SITE ELECTRICAL PLAN AND CALCULATIONS

RESTROOM BUILDING
RELOCATABLE CLASSROOMS

CHANGE ORDER #03

**MYRA A. NOBLE SCHOOL
RESTROOM BUILDING**
BAKERSFIELD CITY SCHOOL DISTRICT
BAKERSFIELD, CALIFORNIA

SITE ELECTRICAL PLAN

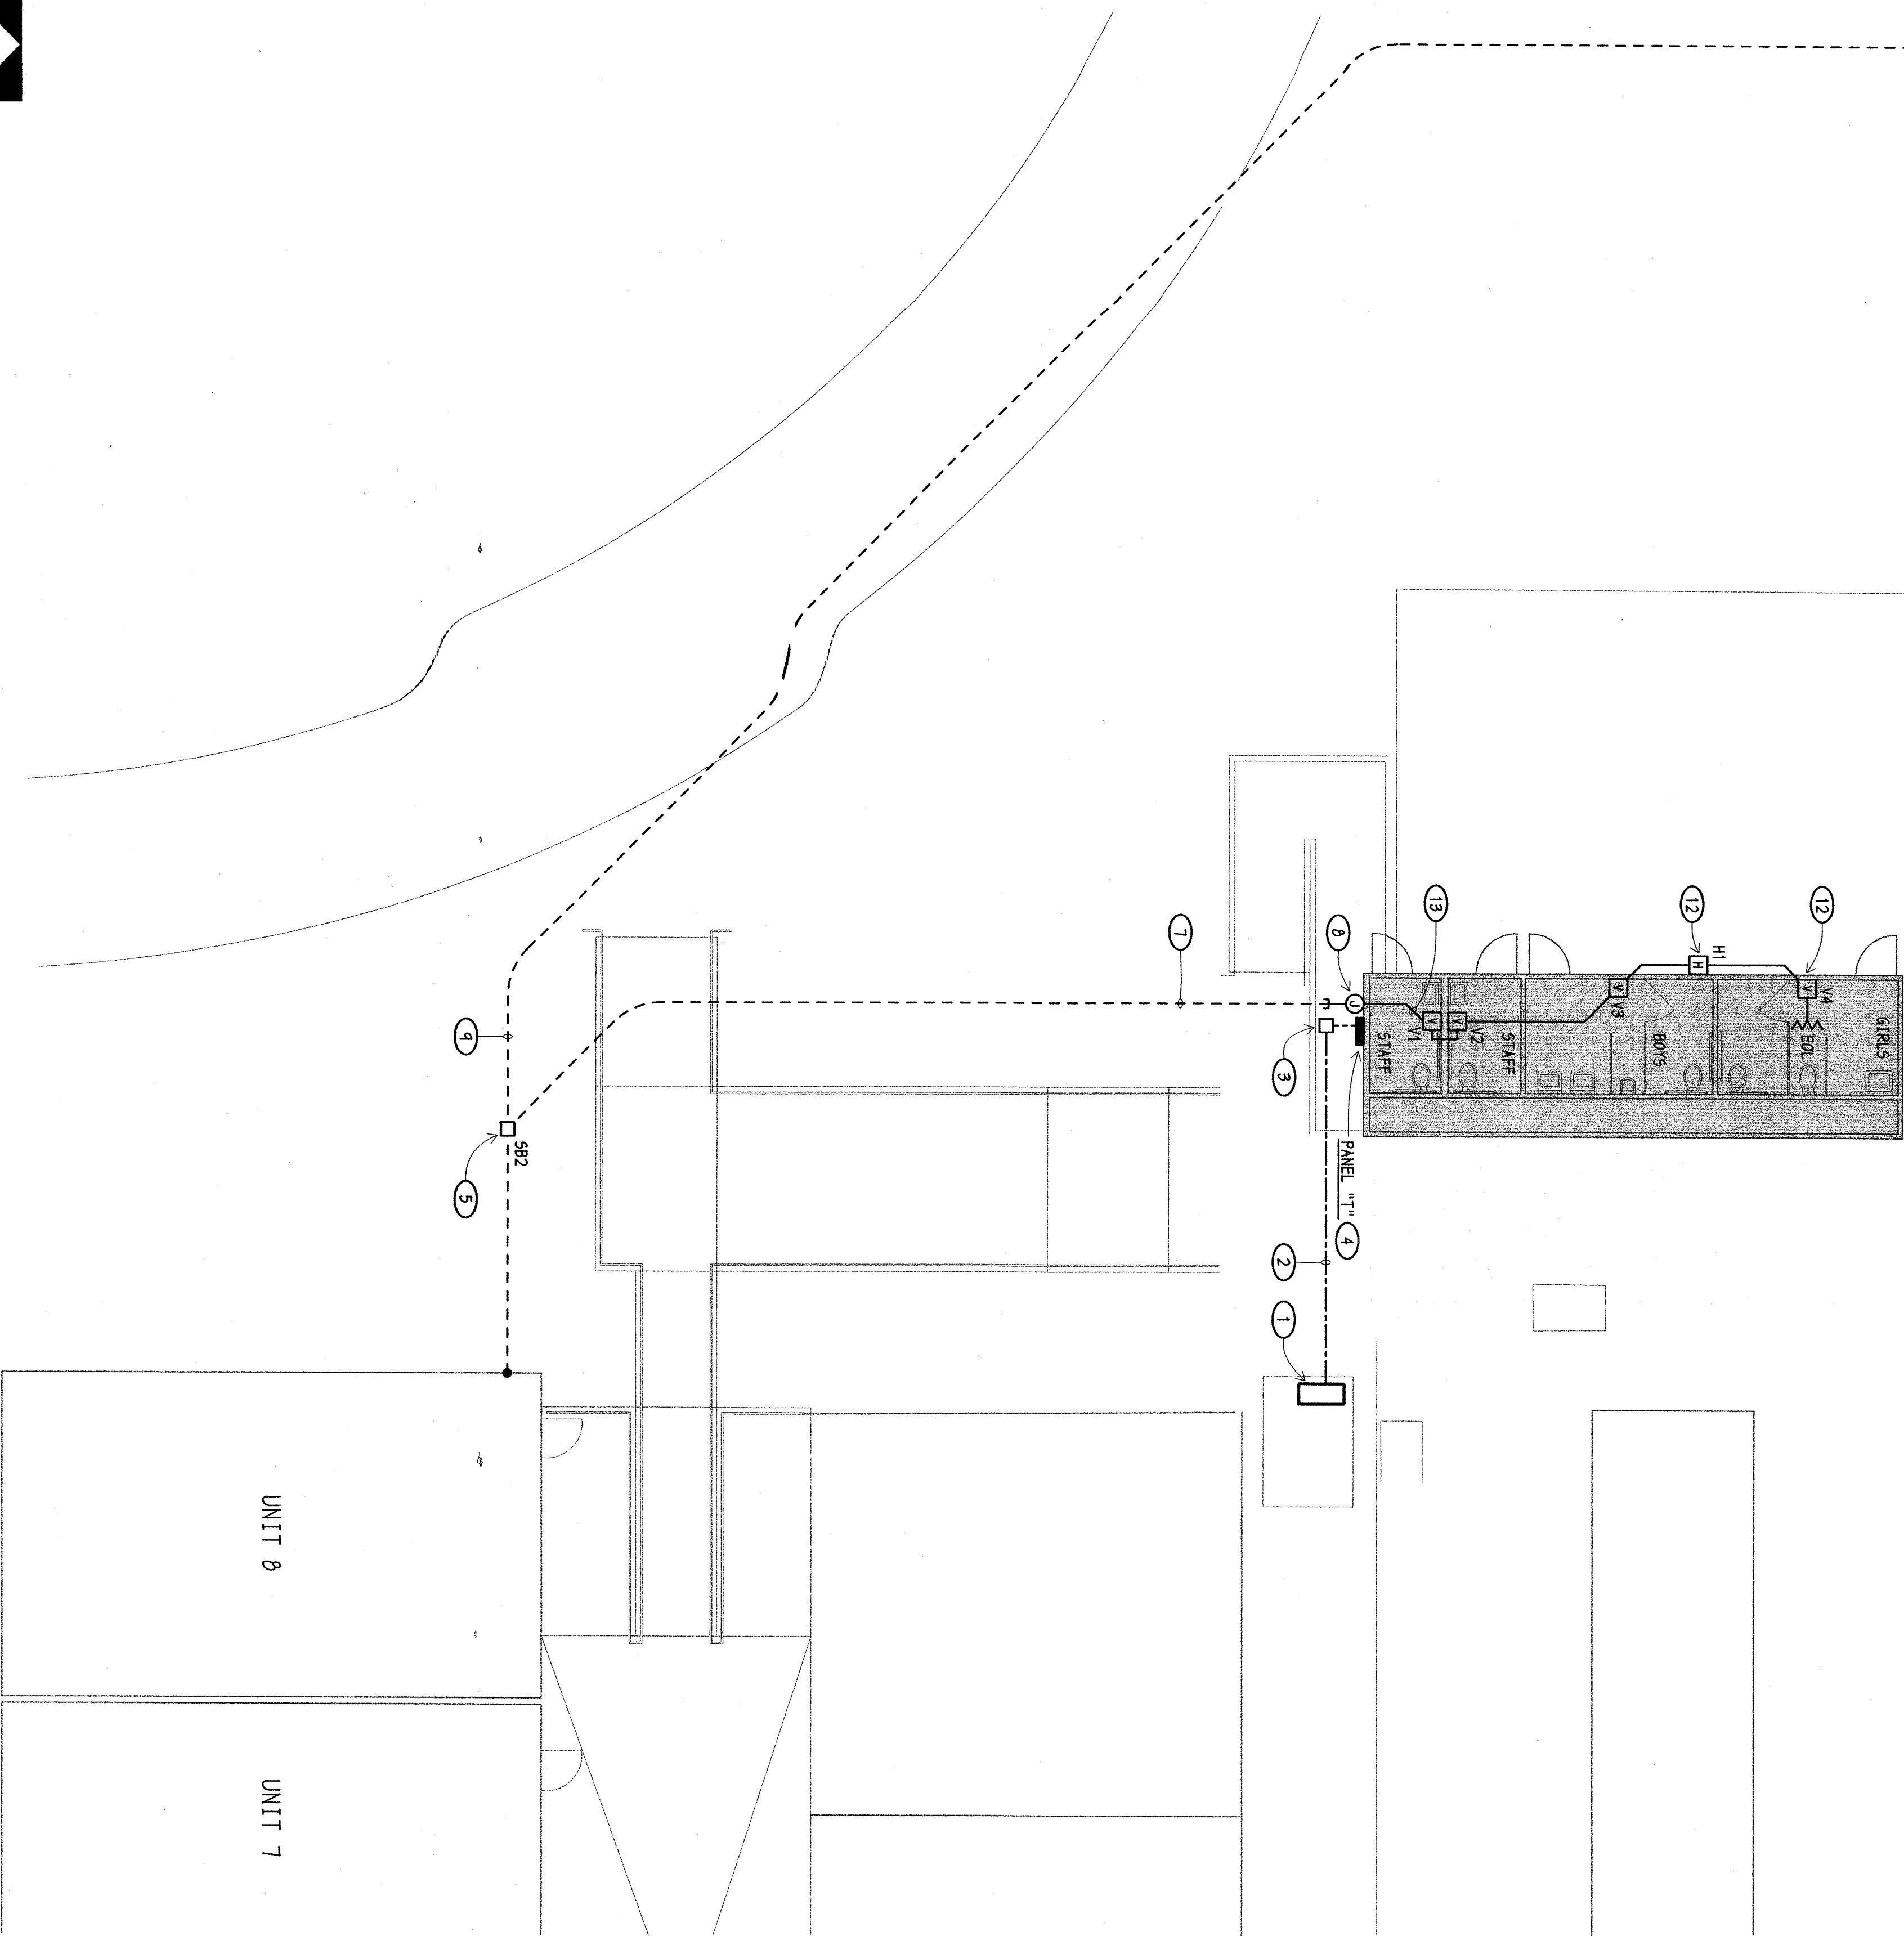
FIRE ALARM SYSTEM VOLTAGE DROP CALCULATION: REVISED

CALCULATION IS WORST CASE VOLTAGE DROP OCCURRING AT FURTHER DISTANCE FROM THE EXISTING FIRE ALARM SIGNAL EXPANDER PANEL VISUAL STROBE AT TOILET BLDG.

BATTERY CALCULATIONS: REVISED

NO DEVICES ARE BEING ADDED, EXISTING
CONDITIONS TO REMAIN THE SAME.
